Bike Winnipeg Recommendations for Bicycle Facilities Connecting to Transit Stations

Submitted February 24, 2017

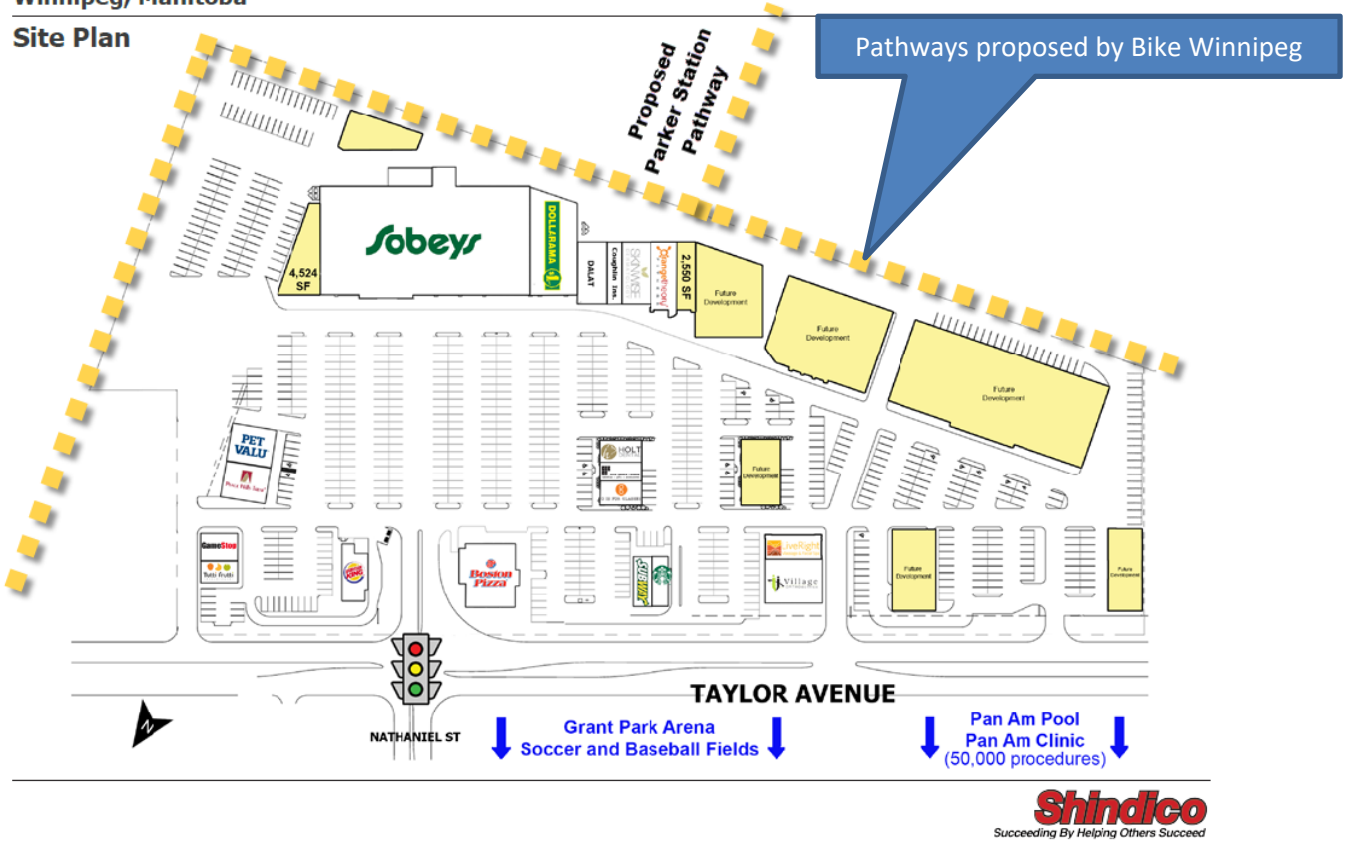
We feel that one of the best opportunities to improve walking and cycling access to Parker Station and the SWRTC in general would be the addition of an AT tunnel connecting Parker Station beneath the CNR Mainline to the Taylor properties, Grant Park Campus, and Grant Park Shopping Centre north of the tracks. This is a very walkable area with a wealth of destinations that is currently somewhat poorly served by transit (at least along Taylor). While the tunnel would benefit the SWRTC, it would also have benefits for both the Oak Grove (Parker Lands) and the Grant Park Pavilions which are under development and could be shaped by their proximity to transit and to each other.

These developments lie within the 800m transit oriented development zone for the proposed Parker Station and would provide a ready market for transit passengers, and would likely see faster and denser development in the presence of a tunnel under the tracks linking Parker Station to these properties. Such a tunnel would also likely help influence the development of the Oak Grove (Parker Lands) development by providing a focal point for transit oriented development along the pathway.

800m Transit Oriented Design Zone north of the tracks that would lie within a 10 minute walk of the proposed Parker Station that would lie within a 10-minute walk if a direct crossing were included in phase II of the Rapid Transit Corridor.

Bike Winnipeg has developed the following cross sections to illustrate our recommended design for the bike and walking facilities along Markham Road.

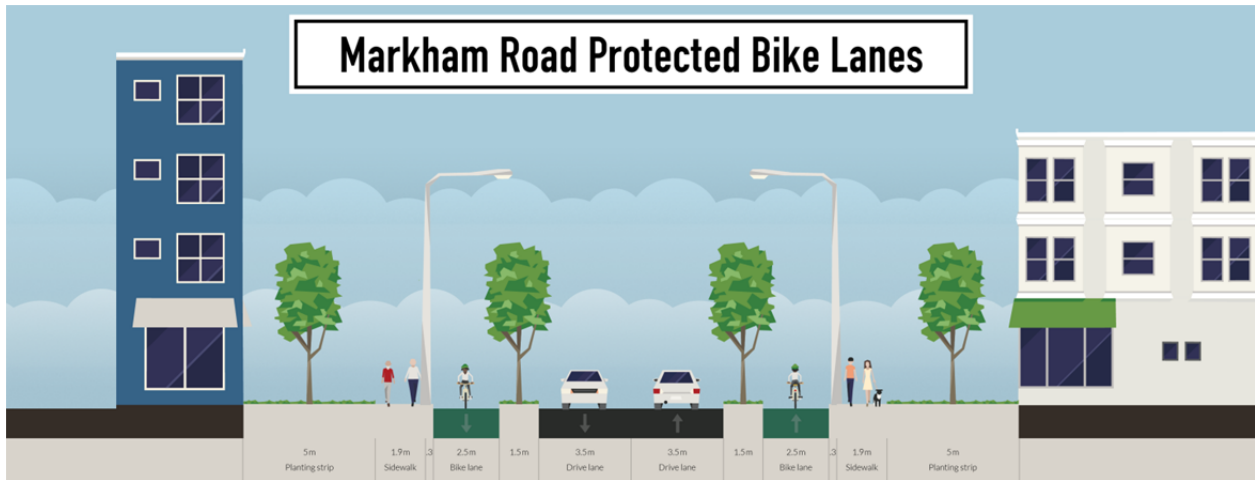
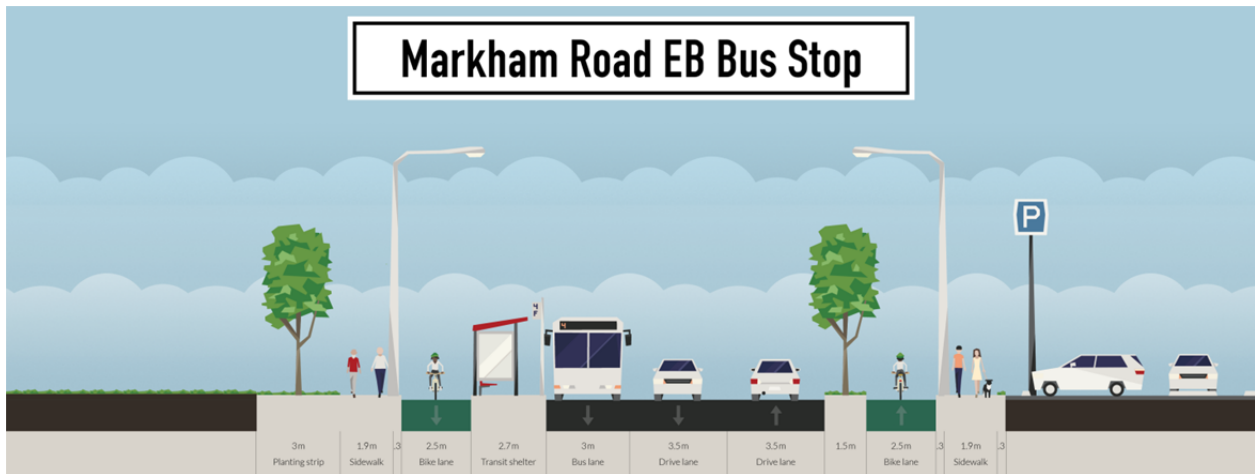
While the plan shown in February did not provide a level of detail for the bike facilities along Markham Road, we feel that a pair on one way protected bike lanes would provide the best functionality for Markham Road. Benefits of one way protected bike lanes include capacity, reduced conflict points at driveways and intersections, and better transitions on and off of the protected bike lanes.

The above cross section should be manageable within the existing right of way along Markham Road. Snow storage may encroach on the bike lanes and sidewalks during winter, but not to the degree that mobility would be sacrificed.

Markham Road WB Bus Stop

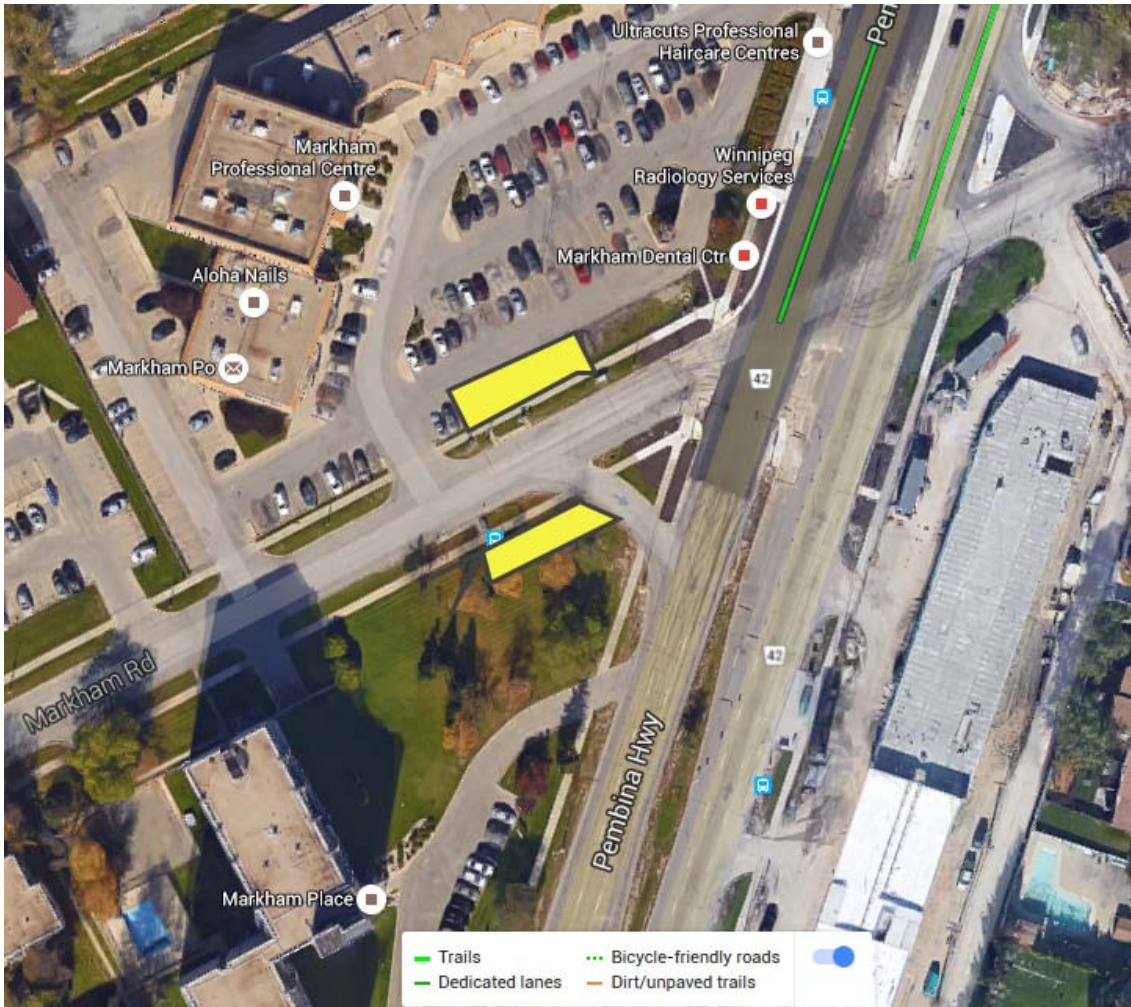
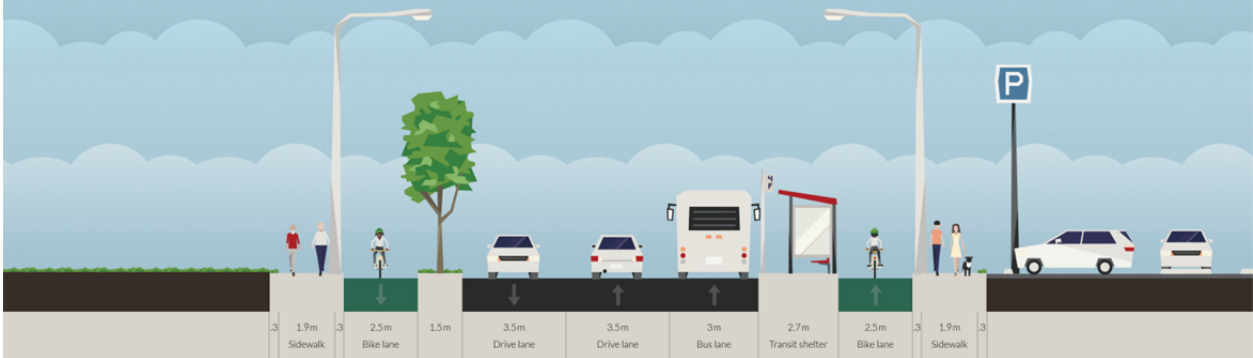
Accommodation of bus stops at the intersection of Pembina and Markham would require acquisition of some property to allow for a bus pullout and platform with a full wrap around for the protected bike lanes. On the south side of Markham, the property desired is currently green space. On the north side of Markham, the property is currently used for off street parking, but this parking could be replaced by expanding parking into an adjacent green space.

Properties needed to provide space for bus pull outs and bus platforms that would allow the protected bike lanes to wrap around the bus stops at Markham and Pembina Highway.

Bike Winnipeg Proposed Cross Sections

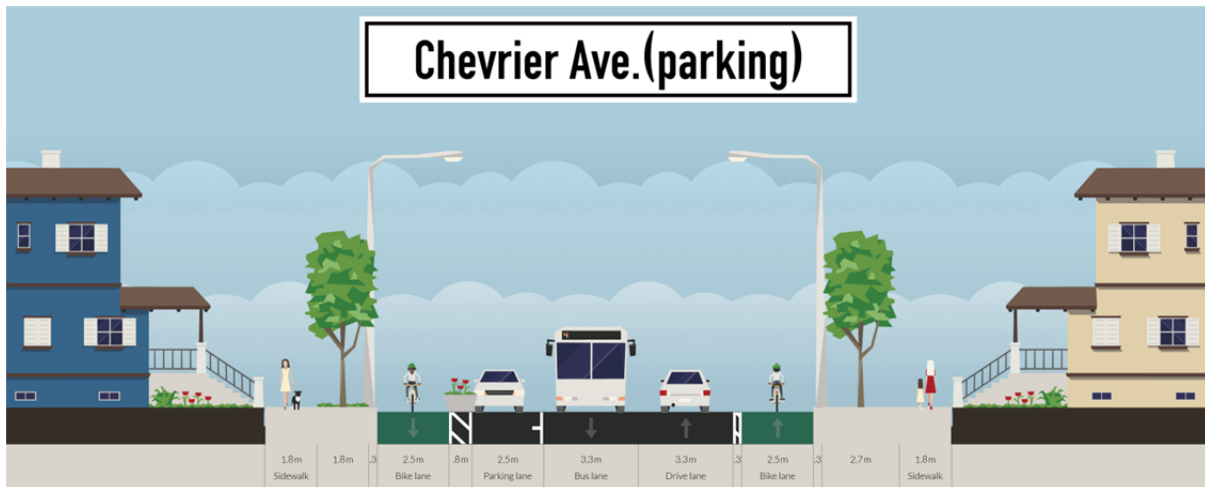
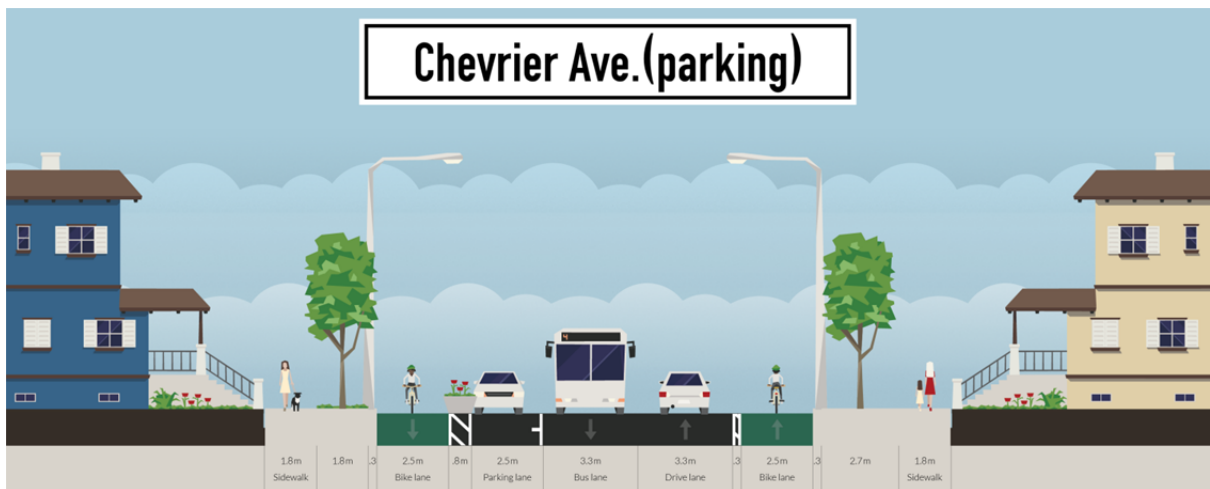
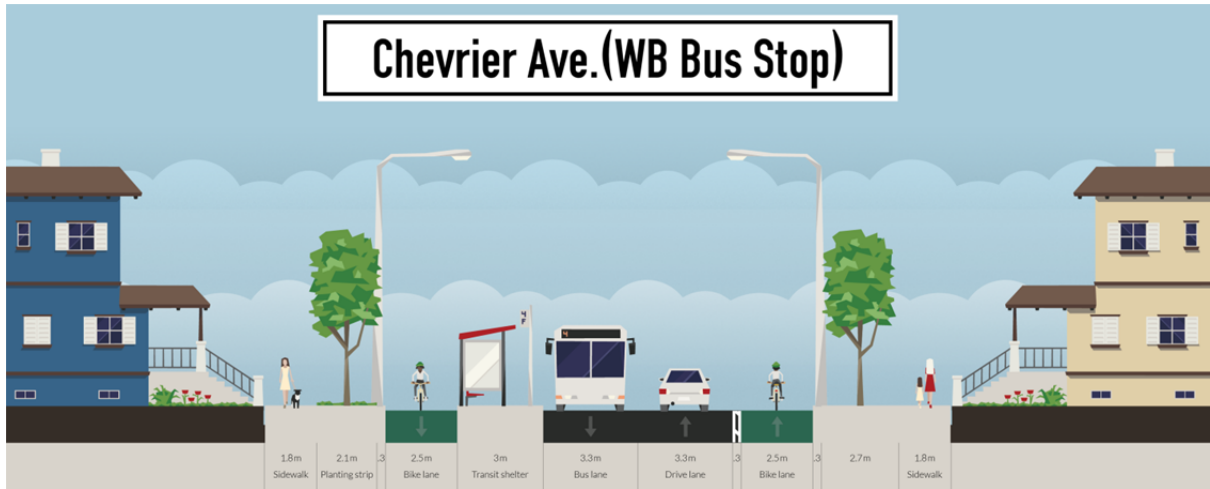
We feel that traffic levels and truck traffic volumes along Chevrier warrant protected bike lanes, as promised in previous stakeholder meetings. Bike Winnipeg recommends the installation of two one way protected bike lanes on Chevrier instead of the two way bike path that has been proposed. Chevrier has a wide 24m right of way, so there is plenty of room to include protected bike lanes on both the north and south side of the roadway with enough width to allow for side by side cycling while still leaving room for snow storage. Raised bike lanes would likely be the most cost effective choice as snow clearance would be straight forward and cost effective.

Exhibit 12
Setback bicycle and pedestrian crossings

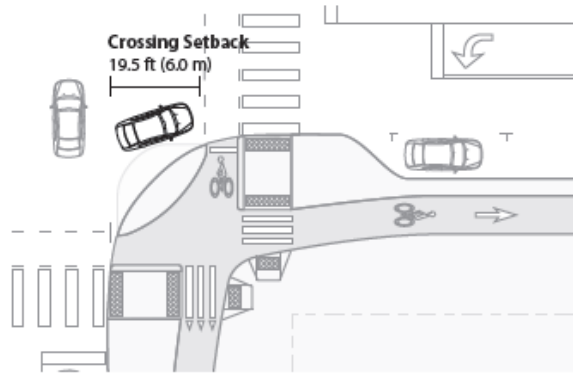
As part of the protected bike lane construction, we recommend that the city get rid of right turn channelization coming off of Chevrier onto Pembina to improve safety. In its place, we recommend that a protected intersection using signal phases to eliminate conflicting movements between bikes/pedestrians and motorized traffic be developed at this intersection.

A setback of 19.5 ft (6.0 m) provides enough room for one passenger car to yield to bicyclists and pedestrians, while waiting outside of the flow of through motor vehicle traffic.

Conceptual design for protected intersection at Chevrier and Pembina taken from Lessons Learned: Building the Protected Intersection

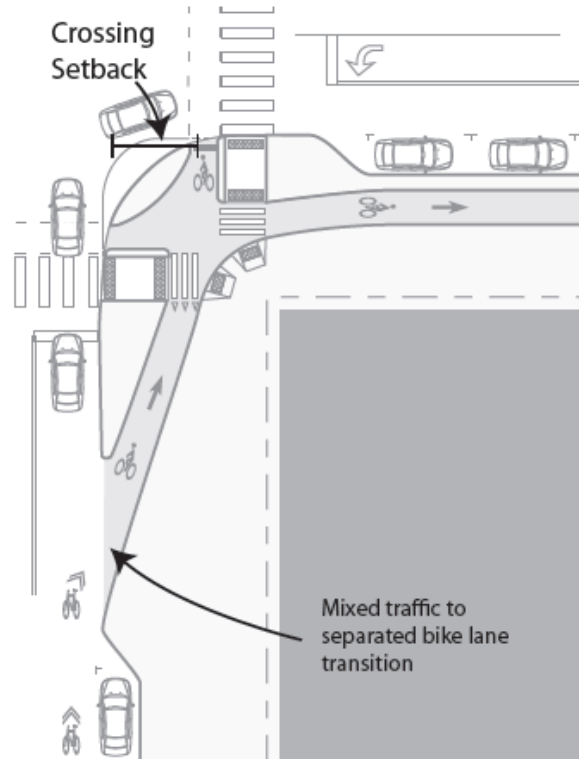
East of Pembina, we could also like to see protected bike lanes installed along Crescent Drive on approach to Pembina to transition into a protected intersection at Pembina & Crescent/Chevrier.

High traffic volumes and high turn volumes (from both people biking and driving) at this intersection warrant the protected intersection at Pembina & Chevrier/Crescent.
